**AGENDA ITEM:** Final Plat and Planned Unit Development (PUD) Plans and Conditional Use Permit for Day Care Facility to be called Growing Explorers Learning Center

The City has received a set of applications from Shamsi, LLC for Final Plat and PUD Plans and a conditional use permit for Outlot A of Boulder Ponds.

To:	Emily Becker, Planning Director	Re:	Growing Explorers (Boulder Ponds Outlot A)
Cc:	Mike Bent, Building Official		Engineering Site Plan Review
	Rob Weldon, Public Works Director		
	Dave Knaeble, Civil Site Group		
	Chad Isakson, Assistant City Engineer		
From:	Jack Griffin, P.E., City Engineer

A Site Plan engineering review has been completed for the Growing Explorers Learning Center to be located on Boulder Ponds Outlot A along Jade Trail North. The submittal consisted of the following documentation prepared by Civil Site Group, Inc., received on August 2, 2018:

C4.0

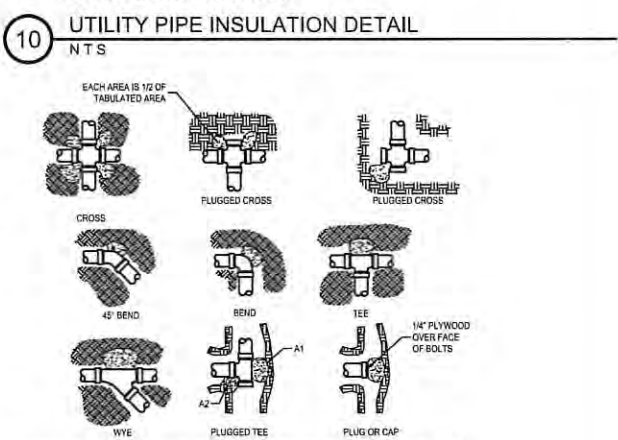
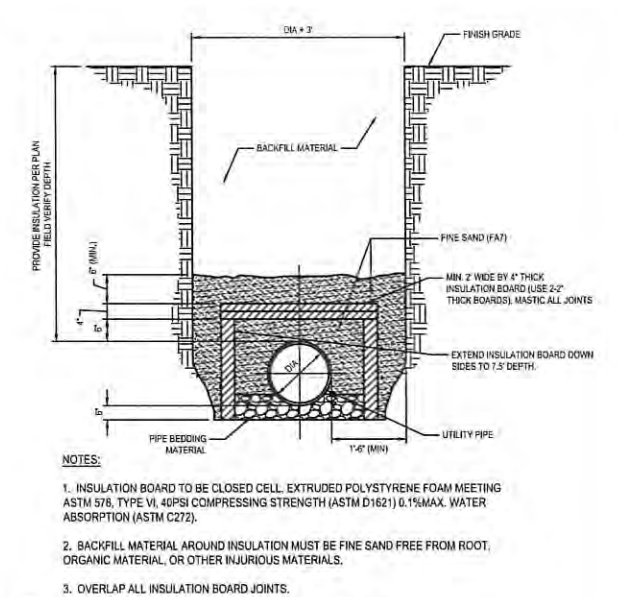
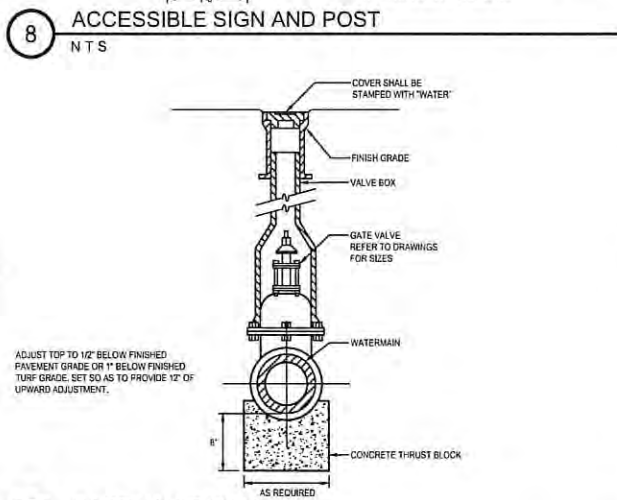
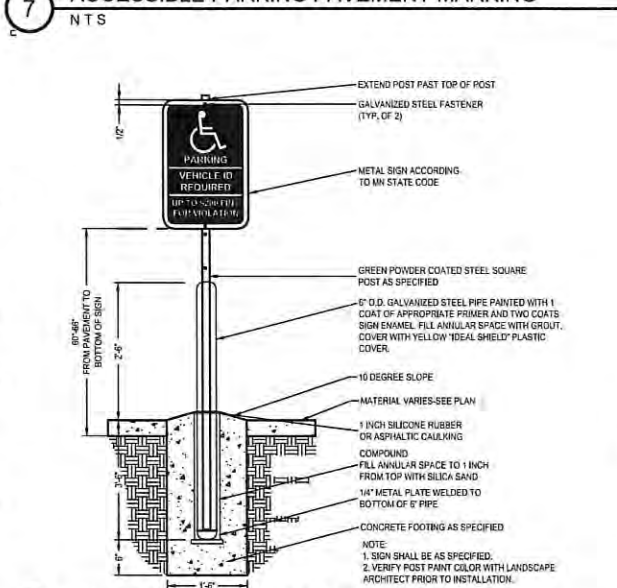
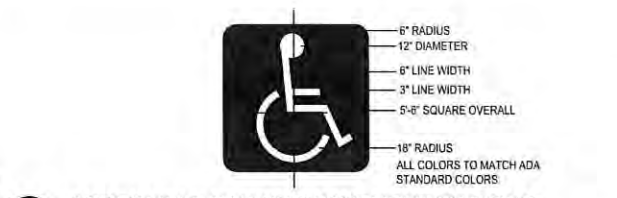
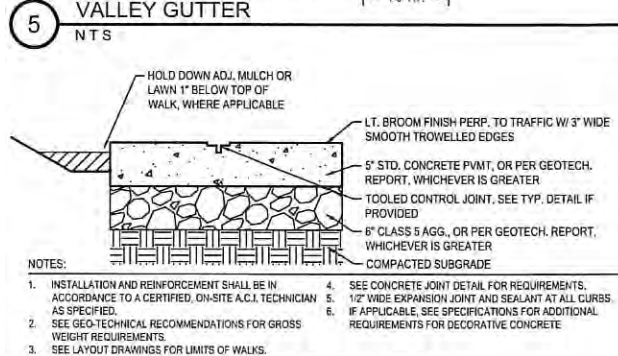
3. C4.0. Add plan note indicating that 100% of the building roof runoff must be captured and conveyed to the storm water basin located on the east side of Jade Trail North. No roof runoff is allowed to drain to the infiltration basin/drainage swale located west of the proposed building on Boulder Ponds Outlot D.

3. C4.0. Identify irrigation service locations, if any, and coordinate landscape plan and utility plan accordingly.
4. Fire Hydrant locations. No new fire hydrants have been proposed. There is one existing fire hydrant located along Jade Trail North approximately 110 feet north of the north Outlot A property line. If fire hydrants are required to be placed interior to the site of Outlot A, the fire hydrants and connecting watermain will be City owned and maintained. If required, the site and utility plans, and project specifications must be revised and resubmitted for City review, showing the proposed hydrants and connection watermain using City design standards, details and specifications. Utility easements must be dedicated to the City, minimum width of 30-feet centered over the pipe and hydrants, and all easements must be shown on the Site Plan, Utility Plan and Grading Plan. City standard plan notes for watermain must be shown on the utility plans.

C5.2

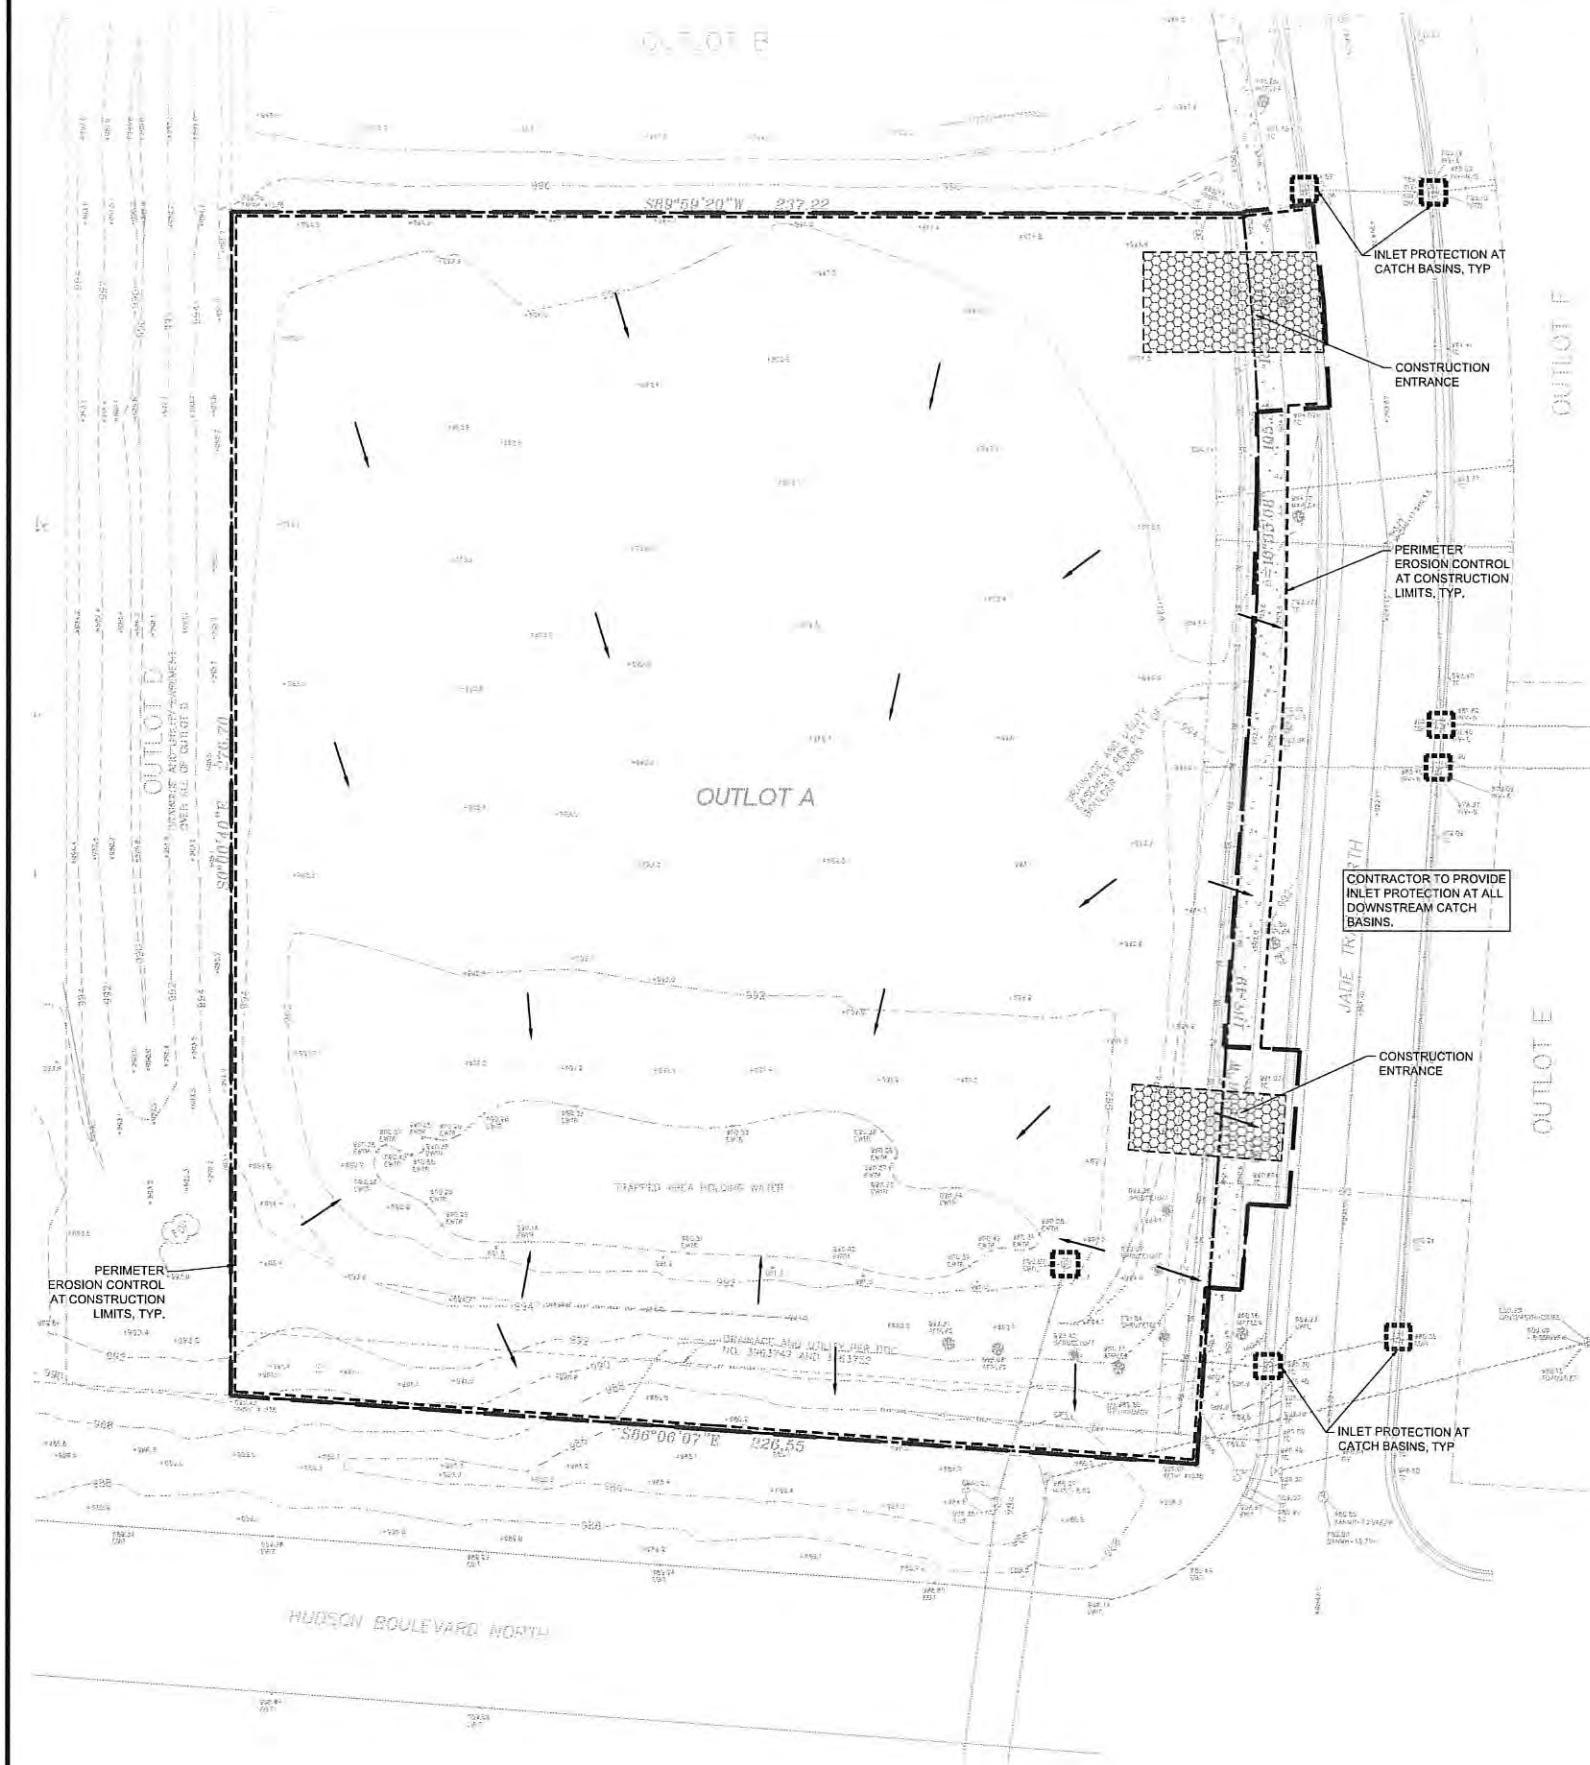
1. C5.0 and C5.1. Add City details 201, 203, 208, 407, 501, 502, 505, 506, 508, 510, and 513. Remove duplicate details.
